REVIEW COMMENTS ON THE PHASE II
REMEDIAL INVESTIGATION SAMPLING PLAN

U.S. DEPARTMENT OF ENERGY
ROCKY FLATS PLANT

TETRA TECH, INC.
FOR
JACOBS ENGINEERING GROUP, INC.
PROJECT NUMBER: 05-8524-00
TC-3621-09

OCTOBER 1988

Figure 3 Existing and DOE proposed bedrock monitoring wells at 903 Pad Mound and East Trenches area

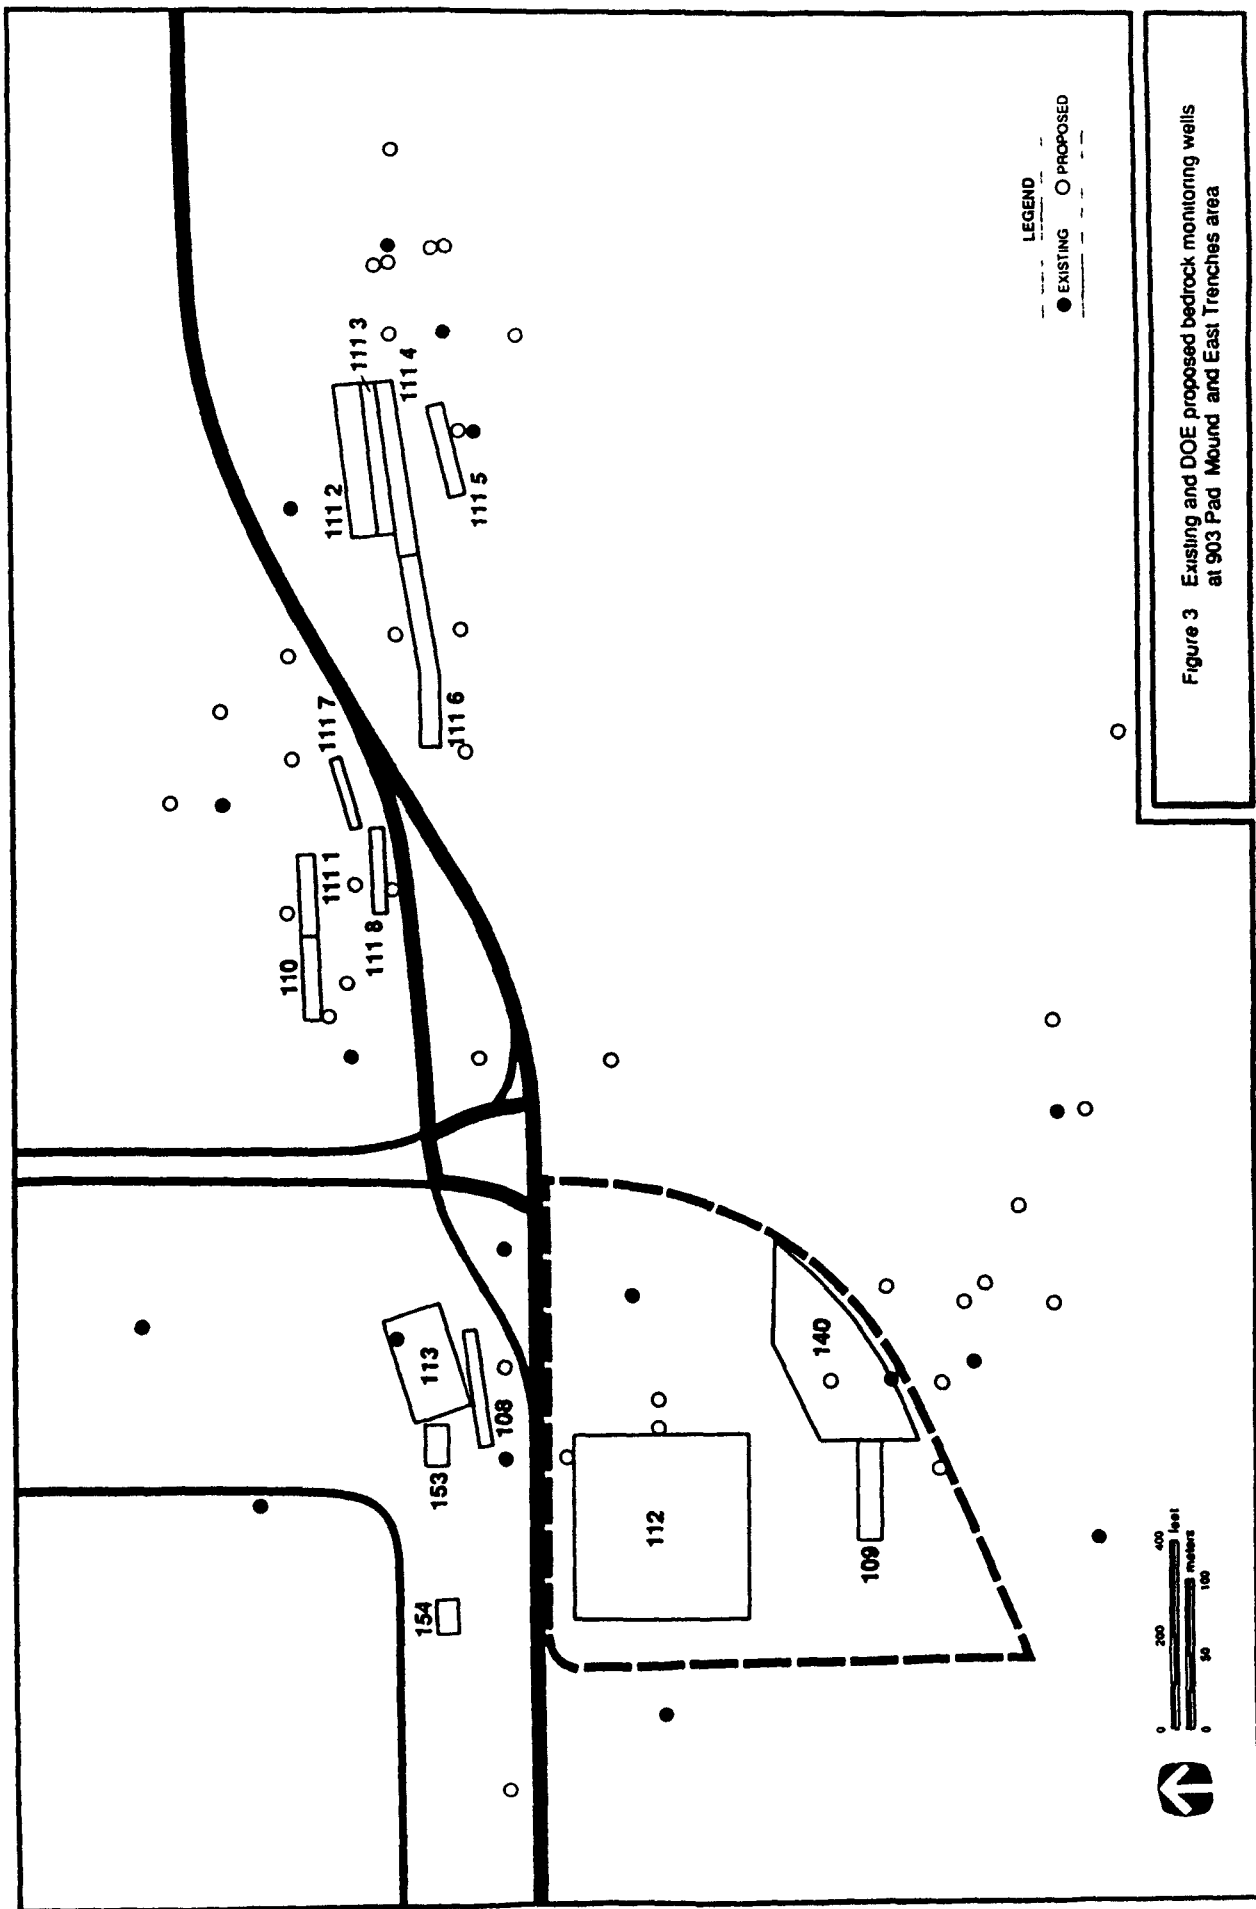
aquifer in previous reports. A basic understanding of the geometry of the groundwater flow path(s) in the bedrock aquifer has not been established. A limited number of hydraulic conductivity tests have been performed for some of the sandstone units. Hydraulic conductivity tests should be performed in wells screened adjacent to the weathered bedrock horizon and the sandstone beds of the Arapahoe Formation. The nature and extent of contamination in the bedrock aquifer is also poorly defined. Only three bedrock wells are located within 50 ft of any of the potential contaminant sources. There are virtually no bedrock wells located in a large area between the 903 Pad and the East Trenches areas (Figure 3).

A basic understanding of the hydrogeology of the bedrock aquifer system, and consequently, the nature and extent of contamination in this system, has not yet been established. Before potentiometric, contaminant plume, and source characterization data for the bedrock aquifer can be evaluated, a better correlation between the sandstone subcrops must be established. Many of the bedrock wells proposed in the Phase II RI plan are located to provide information concerning the continuity, extent, and orientation of the sandstone interbeds. Monitoring well placements are generally not warranted as a primary method for correlation of sandstone subcrops. Boreholes can be used to correlate sandstone interbeds at a lower cost and with greater efficiency than is required to complete monitoring wells. New monitoring wells should be aerally distributed to obtain representative potentiometric surface data, define the nature and extent of contamination, and to provide additional information on sandstone correlations from the accompanying borehole data

In addition, basing correlation of a sandstone on "similar lithologies in relatively closely spaced wells" may not always be accurate. A sandstone may change character, laterally or vertically, over relatively short distances. A potentially accurate method of sandstone correlation would be to use existing monitoring well and borehole locations to perform borehole geophysics (i.e gamma logs). Borehole geophysics is a reliable, relatively inexpensive, and efficient means of correlating subsurface geologic units. Borehole geophysical data would also help verify and add confidence to existing sandstone correlations.
